ADUR & WORTHING
- 9 OCT 2018
PLANNING SERVICES

Ref: AWDM/1311/17; 36 Lesser Foxholes, BN43 5NT

Figure 1: Applicant reported dimensions and actually measured building to fence dimensions

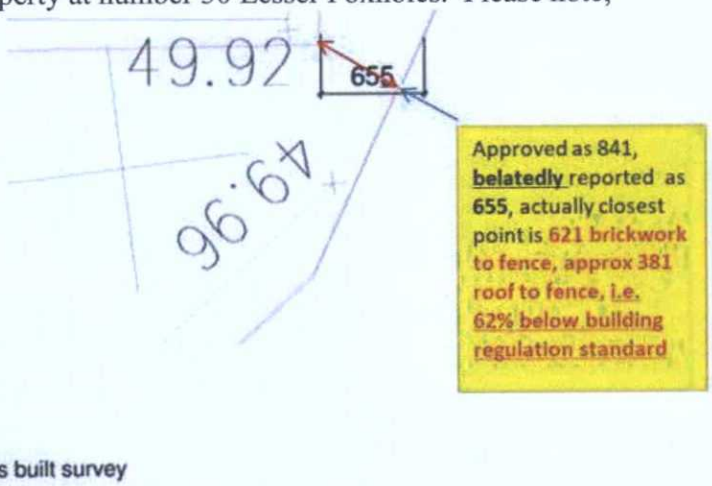
1) The Applicant did not volunteer the incorrect siting; the neighbours reported it.
2) The Applicant's response is 3 months after the neighbour's report to A&W Development Management; this is presumably a "Force Majeure" ploy to disincline any rework and fault correction.
3) Adur and Worthing Building regulations staff made no checks regarding the building proximity to the boundary. This is surprising, especially as the building was already passed with a "reduced" 841mm proximity to the boundary, i.e. below the normal 1000mm Building regulation.
4) Having failed to report the error, the Applicant's stated survey value (in their application of 7th September) of 655mm from wall to boundary is 35mm larger than the measured value to the fence erected by the Applicant, i.e. the proximity from wall to fence is 620mm at the closest

corner point, not 655mm. The Applicant's covering letter attempts to hide this anomaly with a description of a "slight shift towards the east", actually 35mm.

5) The bungalow is therefore 221mm (8.7 inches) closer than originally approved dimension, a very useful development gain in terms of providing more space between the bungalow and its neighbouring house on the site....***shame about the "minor/immaterial" effects on the other neighbours, but so what, we can probably get away with it!***

6) The corresponding distance from the bungalow's roof to the boundary will probably be 380mm...a 62% reduction from the building regulation's 1000mm.

Figure 2: suggested modification to northeast corner of bungalow to reduce intrusive proximity of building arising from non-conformance to plan and building errors

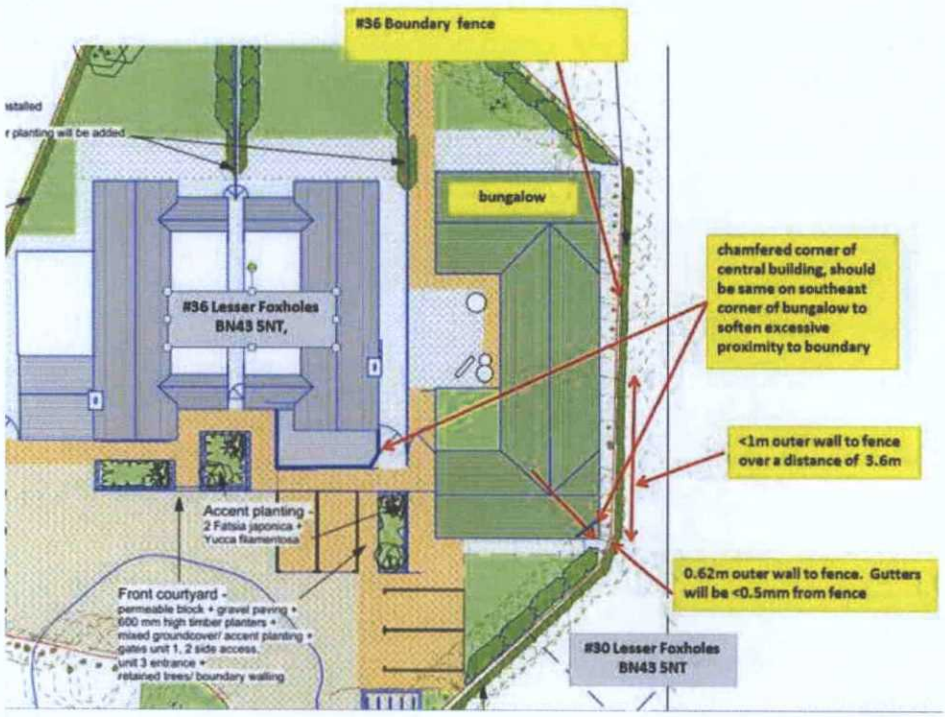
It is suggested that the Applicant adjusts the northeast corner of the bungalow with a 1 metre chamfer or angled face (Figure 2), as has been used on the adjacent building (Figure 3), in order to soften the proximity of these gross building transgressions. The chamfer would be in an unloaded portion of the wall and can be readily modified in the existing brickwork, as was the case with the chamfer on the adjacent building in Figure 3. Although the Applicant may be dis-inclined to do any rework, the Applicant should be tasked to increase the local proximity in consideration of firstly ignoring building

regulations, secondly of not reporting the non-compliance with the approved plans, and thirdly of providing misleading and information on the bungalow's position in their latest application.
